HISTORIC AND DESIGN REVIEW COMMISSION

HDRC CASE NO: 2017-458
ADDRESS: 323 DEVINE ST
LEGAL DESCRIPTION: NCB 725 BLK 7 LOT 11 & 12 AT 323 DEVINE
ZONING: RM-4, H
CITY COUNCIL DIST.: 1
DISTRICT: Lavaca Historic District
APPLICANT: Nate Manfred/French & Michigan
OWNER: Chris Coffey Megan Luke
TYPE OF WORK: Porch Restoration; Screen restoration
REQUEST:

The applicant is requesting a Certificate of Appropriateness for approval to:

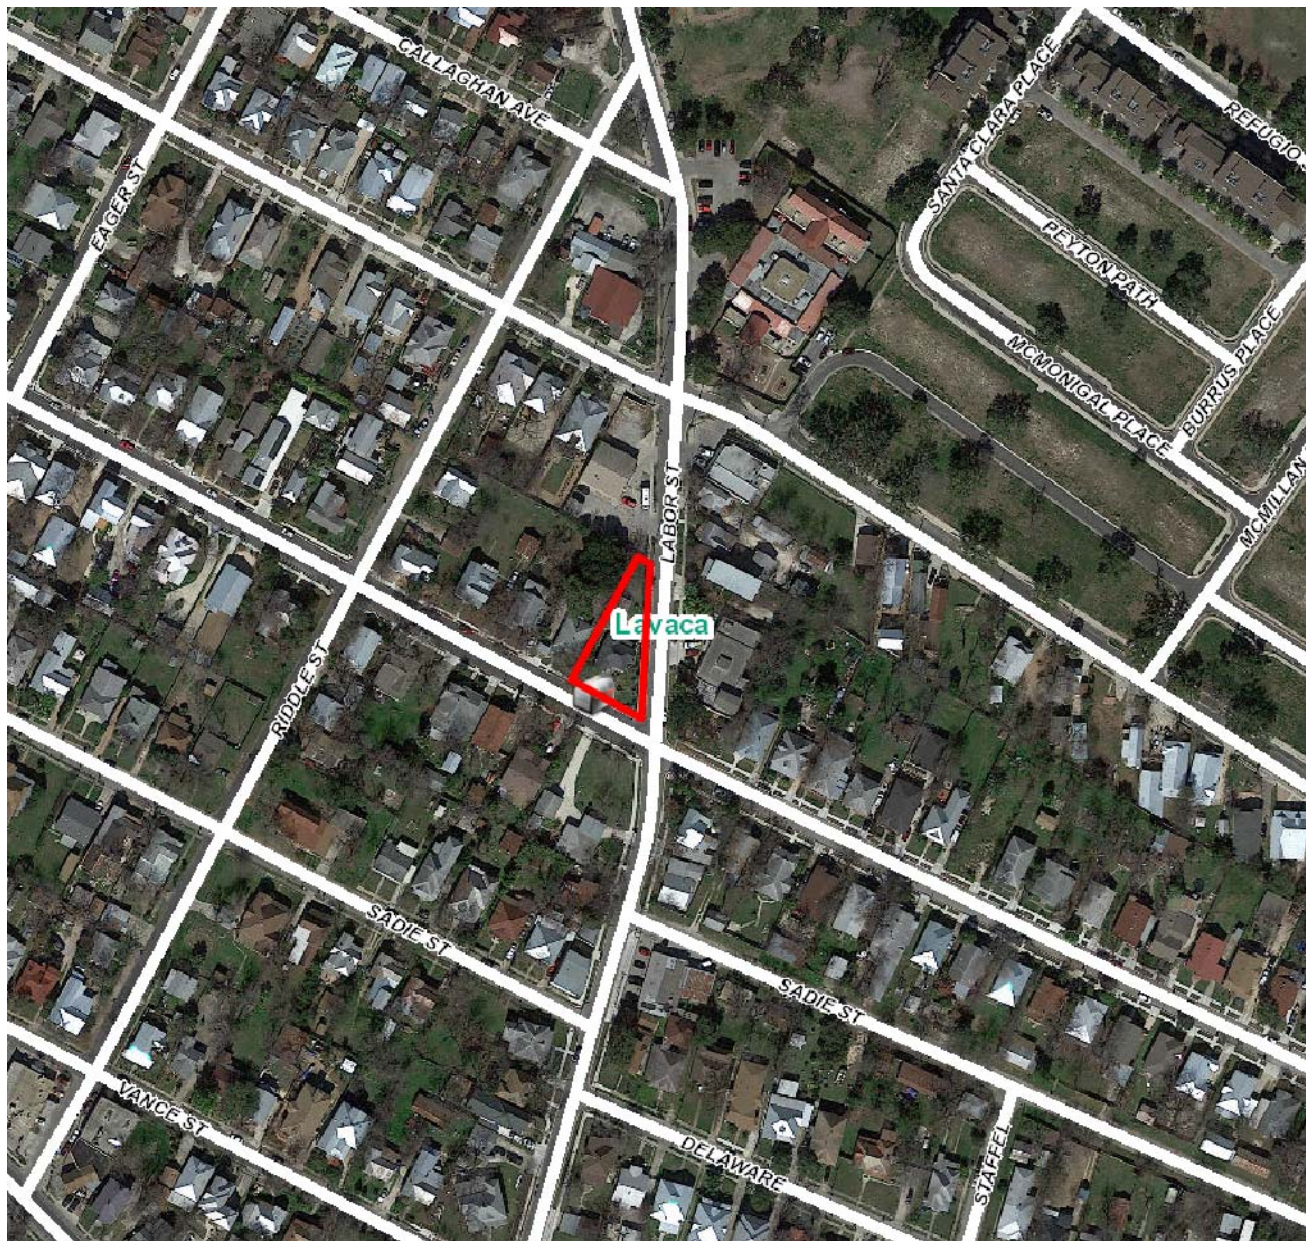
- a. The structure at 323 Devine was constructed circa 1900 and is found on both the 1904 and 1912 Sanborn Maps. The structure was constructed in the Folk Victorian style and originally featured a wraparound porch. Elements that currently exist are both front and side window bays, front and side gabled roofs and a hipped roof.
- b. REHABILITATION – The applicant has proposed rehabilitative scopes of work that include repair to the original wood windows, wood window screens and painting the structure. Staff finds the proposed rehabilitative scopes of work to be appropriate and consistent with the Guidelines for Exterior Maintenance and Alterations.
- c. PORCH RECONSTRUCTION – As noted on Sanborn Maps, this historic structure once features a wraparound

front porch. At this time, the applicant has proposed to reconstruct the porch to match the footprint noted on the 1912 Sanborn Map. The applicant has proposed for the reconstructed porch to feature a standing seam metal roof, decorative round wood columns, lap siding for skirting, $\frac{3}{4}$ " tongue and groove decking and a depth of 6' – 3". Per the Guidelines for Exterior Maintenance and Modifications, porches should be reconstructed based on accurate evidence of the original. If no such evidence exists, the design should be based the architectural style of the house. Staff finds the proposed porch restoration to be architecturally appropriate and consistent with the Guidelines.

- d. RAILING – The applicant has proposed porch railings for the proposed reconstructed porch. Staff finds the installation of railing to be appropriate; however, a dimensioned detail should be provided to staff.

Staff recommends approval as submitted based on findings a through c with the following stipulations:

- i. That a detailed elevation and photo of a porch within the Lavaca Historic District that will serve as an example for the proposed reconstruction be submitted to staff for review prior to the issuance of a COA. The detailed elevation should also include a railing detail.
